Baldwin County Planning Commission Staff Report

Case No. SPP25-20
Long Bayou Preserve
August 7, 2025

Plat

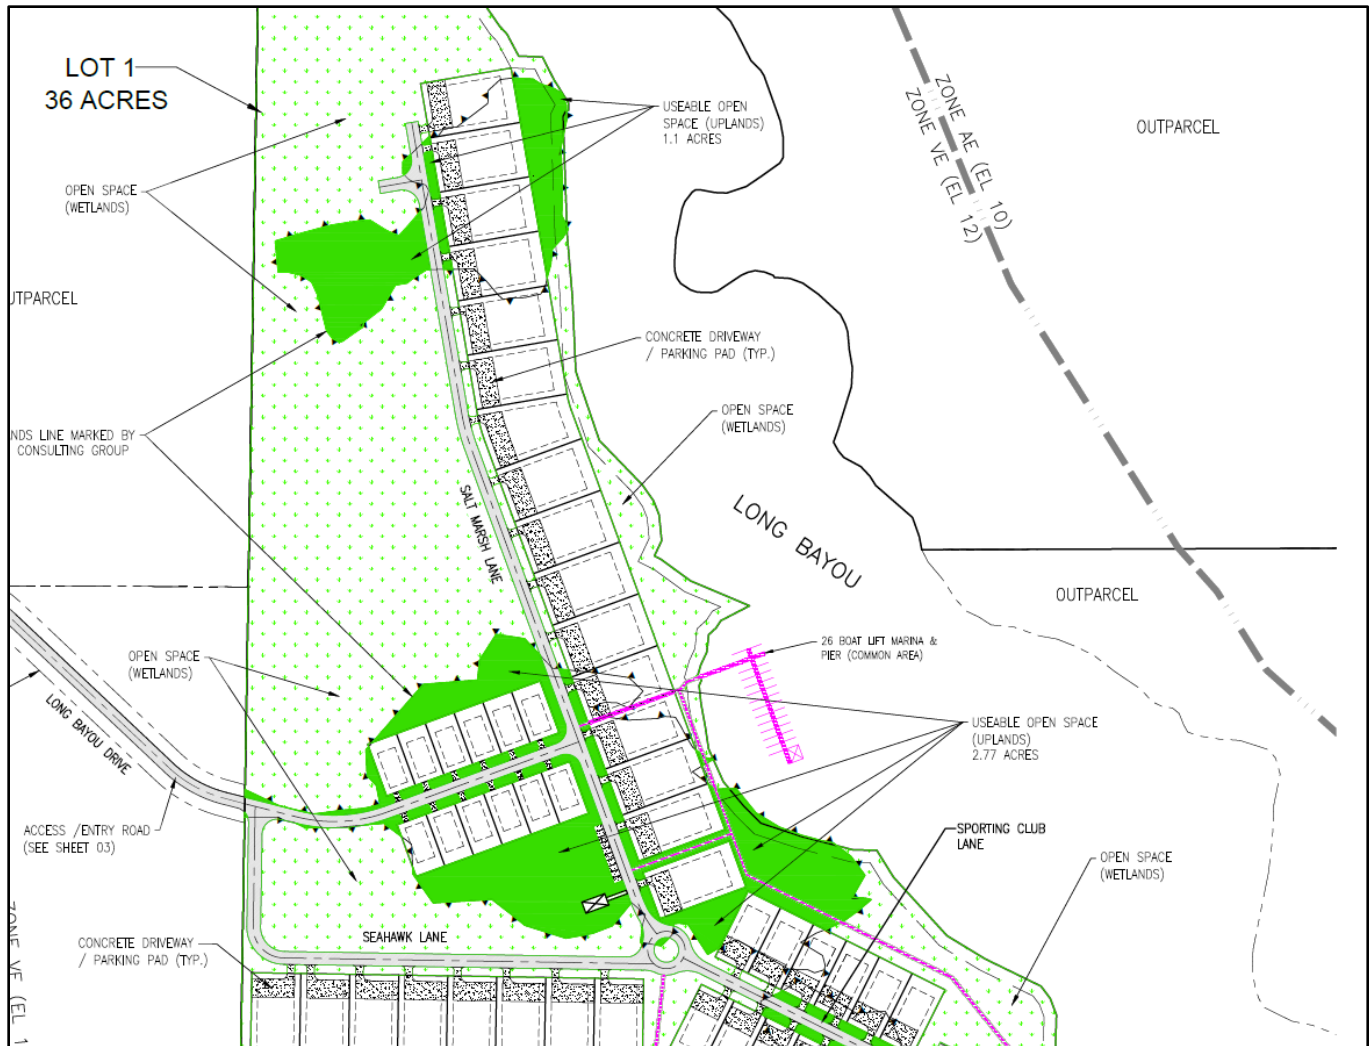
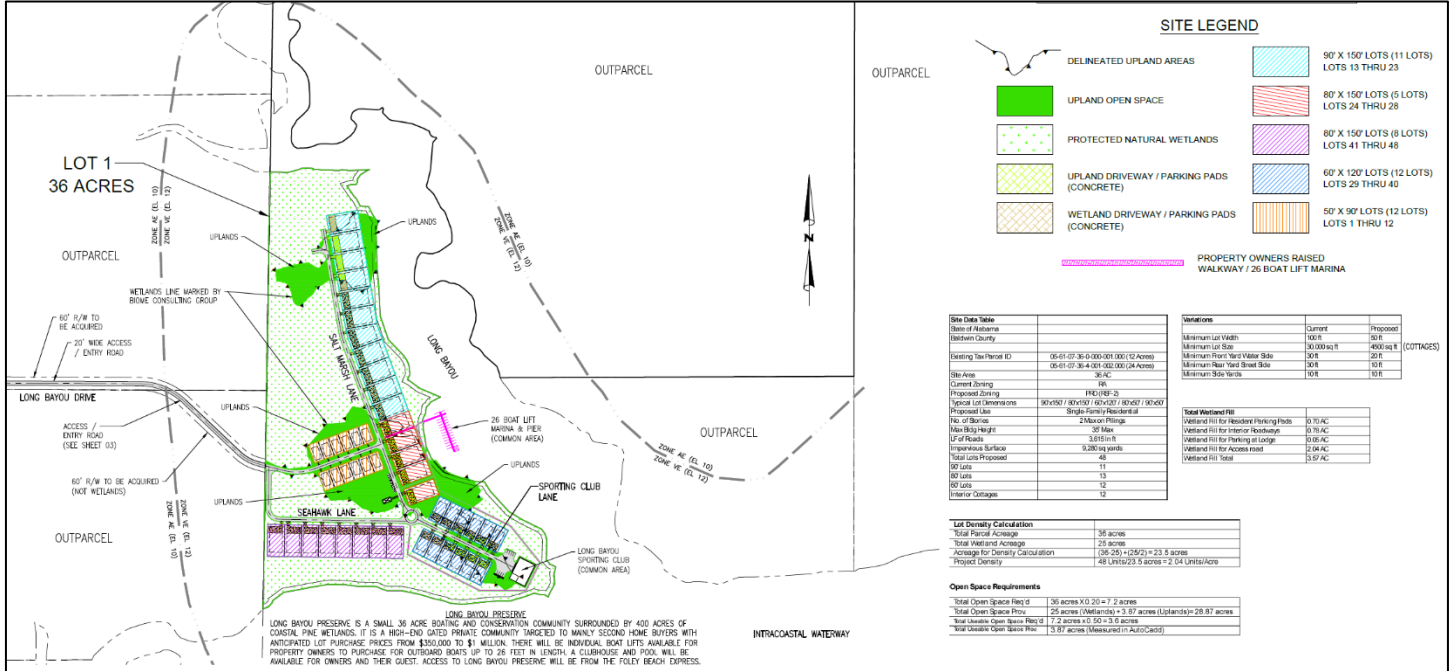
Staff recommends that the PRELIMINARY PLAT for Case No. SPP25-20 Long Bayou Preserve be **Approved with conditions** subject to compliance with the Baldwin County Subdivision Regulations

Specific conditions:

1. Applicant shall provide staff a copy of the purchased mitigation credits for the proposed wetland areas that will be filled in accordance with the USACE approval prior to submitting an application for construction plans review (CPR)
2. Applicant shall record new deeds along with exemption PF25-74 for the public acquisition to divide the parent parcels of the proposed subdivision.
3. The applicant shall submit a written waiver request to staff for review, citing the infeasibility of broadband availability as confirmed by the respective utility companies
4. Applicant shall provide staff a "will serve letter" from the proposed waste collection.

5. Applicant shall submit a private road request to the County Commission after receiving subdivision permit approval from the permit engineer, as the proposed roads will not be accepted by Baldwin County and are to be developed as privately maintained roads.
